Closeout Presentation

Director's Independent Design and CD-2/3 Review of the LHC CMS Detector Upgrade Project

May 28-30, 2014

Table 1: Cost summary for DOE and NSF Scope

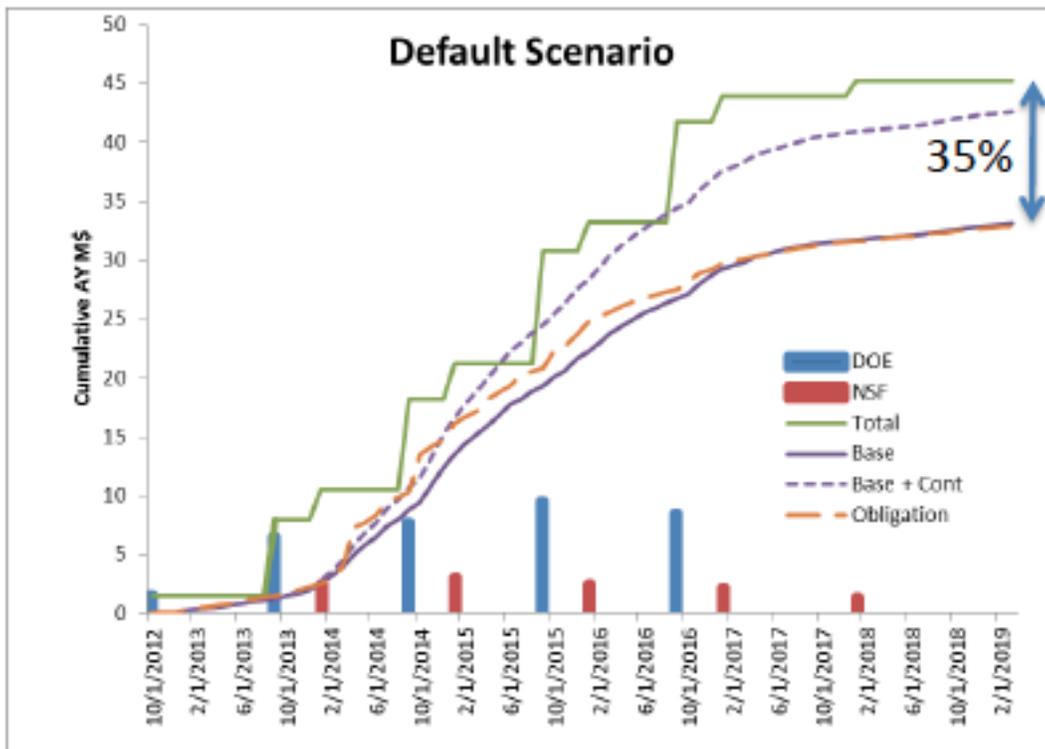
- The BA vs BO chart shown reflects a cash flow problem in FY15. The Project Team stated they are working on scenarios to address this problem.
